# DOMETIC HEATING FURNACES

## EN Furnace Limit Switch Service Bulletin

Model	Serial Number Range
All Small & Medium Furnaces (AFS, AFM, DFS, DFM)	73985322 – 81099541

### 1.2 Installing the fiberglass sleeve

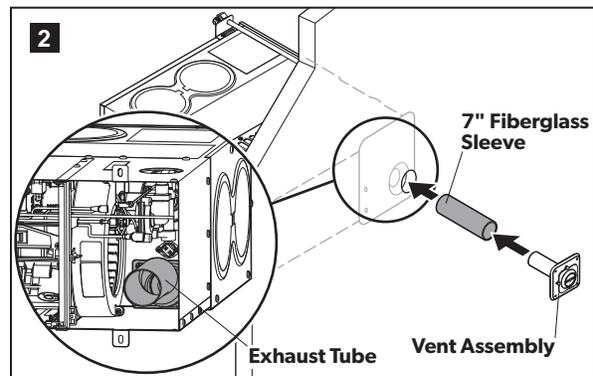
The cause of this nuisance issue is a mistaken omission of a plastic wire tie to suspend the heat exchanger limit switch wires up and away from the exhaust tube vent terminal. The omission of this component allows the limit switch wires to potentially melt on the vent terminal, shorting to ground, and causing either the fuse or circuit breaker in the circuit to blow, or the sail switch to become inoperative. **In ALL cases the safety devices in the system are performing as designed and prevent the furnace from operating.**

Dometic recognizes this nuisance tripping issue is an inconvenience to our OE and potential end-use customers and we apologize for the extra work that may result. In an effort to try and reduce the amount of work required to correct this mistake we have designed and tested a field repair for this occurrence which will be more expensive for Dometic but will make the field repair much easier. The repair will consist of sliding a 6" long, high-temperature rated, fiberglass sleeve over the exhaust tube after removal of the vent assembly. The field repair kit will be available within March, 2018. The field repair kit part # is 31389, Flat Rate Time is .5 and the fault code is 617.25.

## 1 SLEEVING THE EXHAUST TUBE
